A55 Junctions 14 and 15 Improvements

Walking, Cycling and Horse-Riding Review

A55 JUNCTIONS 15 AND 16 IMPROVEMENTS WALKING, CYCLING & HORSE-RIDING REVIEW (PRELIMINARY DESIGN)

Project name **A55 J15 and J16 Improvements**
Project no. **1620000620**
Recipient **Welsh Government**
Document type **WCHAR Review**
Version **F01**
Date **21/10/2020**
Prepared by **Nicola Evans/Ioannis Spyropoulos**
Checked by **Rob Griffiths**
Approved by **Steve Chewins**
Description **Walking, Cycling & Horse-Riding Assessment Report Review**

Project No:	Scale (@A1):	Drawn:	Date:
1620000620	AS SHOWN	DB	OCT 19
Drawing No:		Rev:	
A55J15J16-RAM-60-16-DR-C-0001			I01

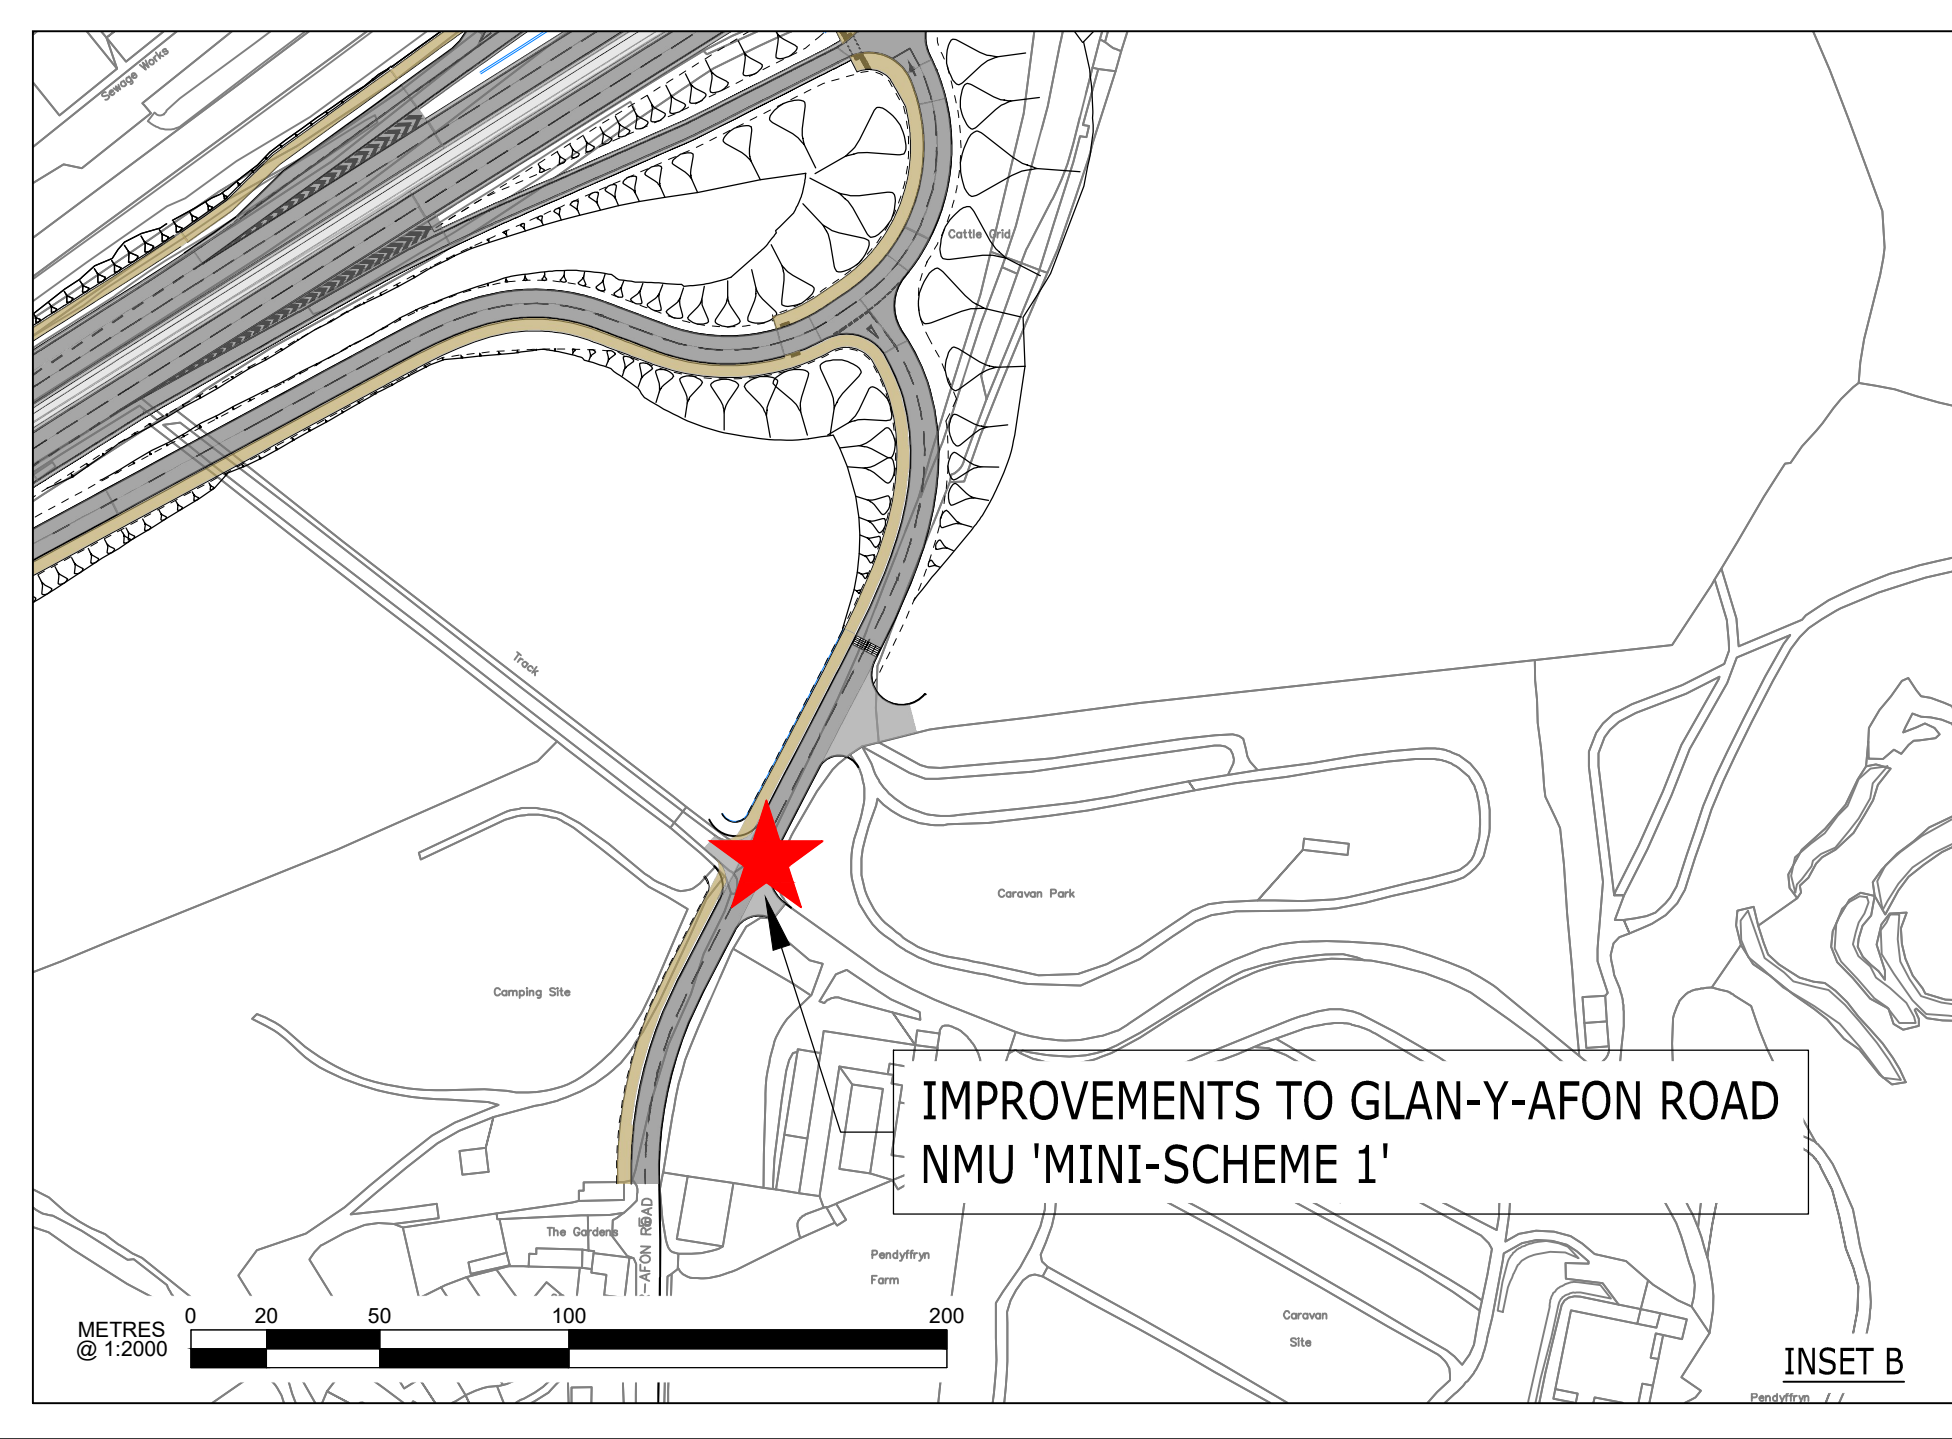
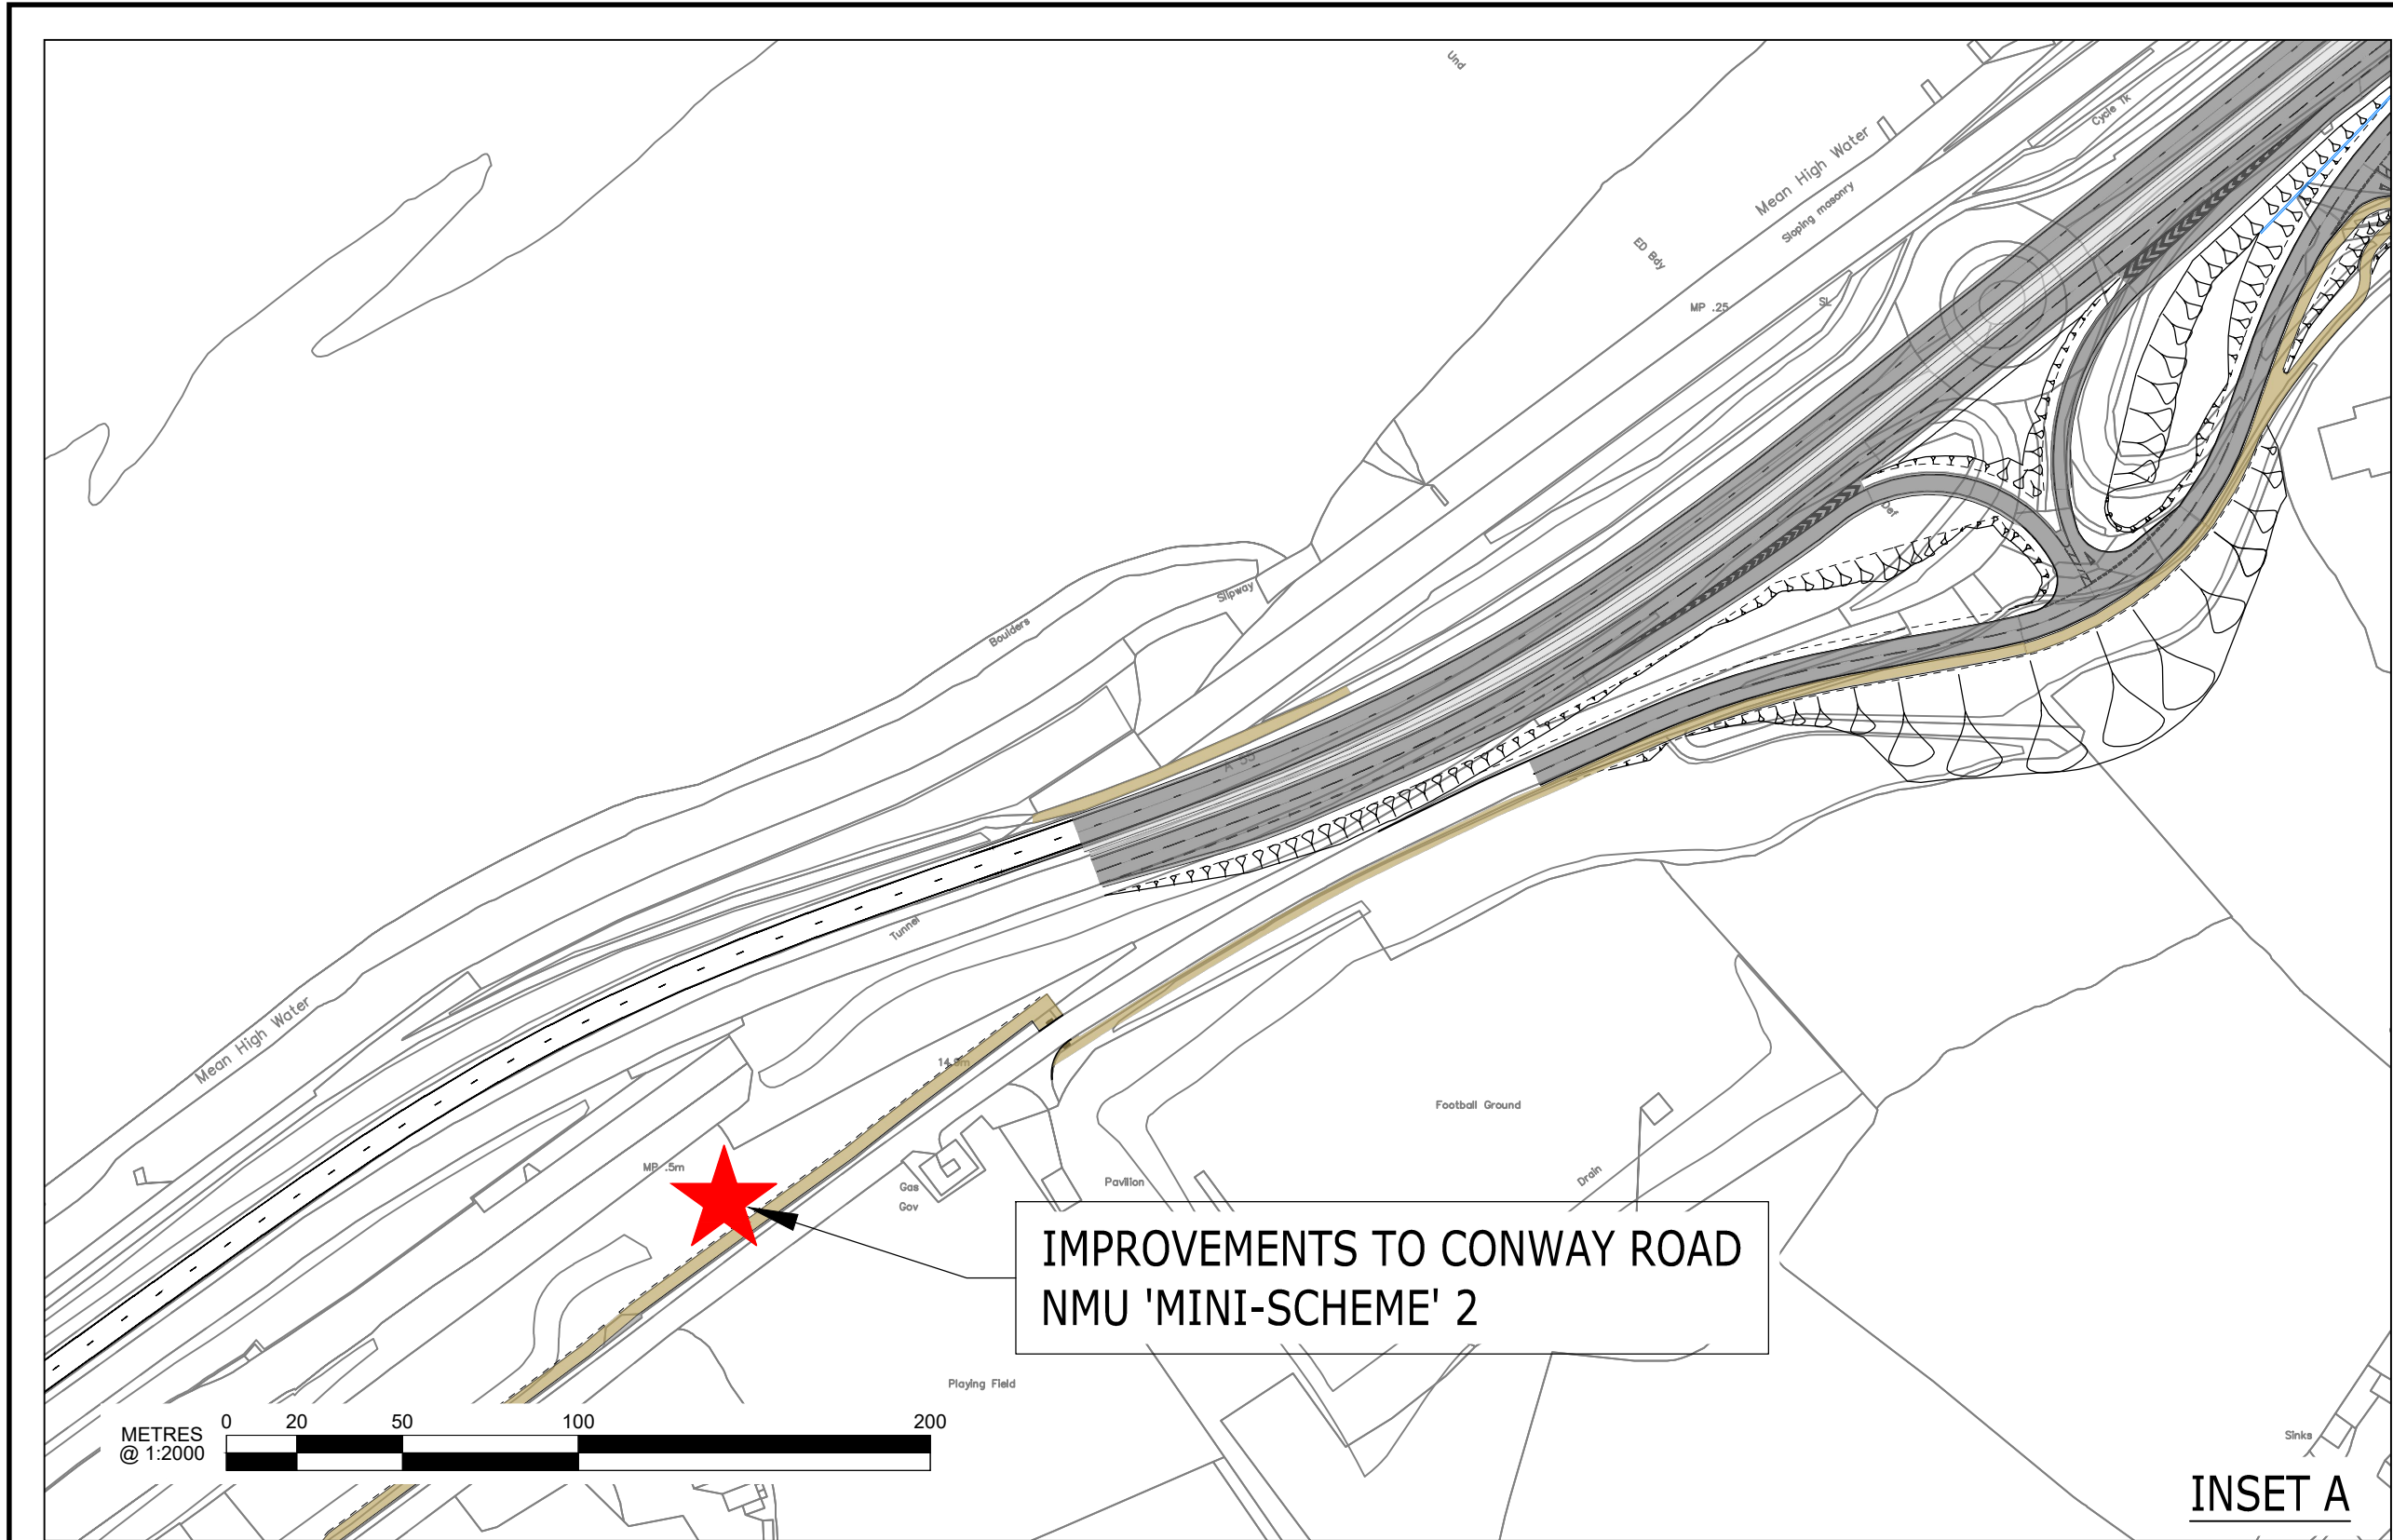
NMU Mini Scheme 1: Improvements to Glan-y-Afon Road

A new 160m cycle/footway along Glan-y-Afon Road would provide improved connectivity to Dwygyfylchi from the east and to the proposed new segregated route along the new link road towards Penmaenmawr. The improvements would include a route avoiding the replacement cattle grid on to the signalised crossing at the proposed overbridge, where provision would be made for cyclists and pedestrians.

NMU Mini Scheme 2: Improvements to Conway Road

Consists of a 400m segregated cycle/footway along Conway Road, providing connectivity between Dwygyfylchi and Penmaenmawr.
